COBRA Guidance Note

Background

Figure 1 - Internal Exhaust Valve

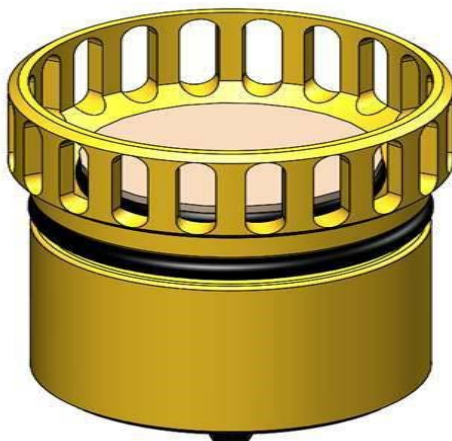
After fitting the revised scrubber housing to clients' COBRA sets, JFD technicians found that, during bench testing, the head exhaust valves were sticking.

Investigations found that due to the period of inactivity, both the internal and external exhaust valves (Figures 1 and 2) had become sticky and did not vent at the correct pressure.

If users also experience this problem, the relief valves should be removed from the COBRA set, cleaned and refitted.
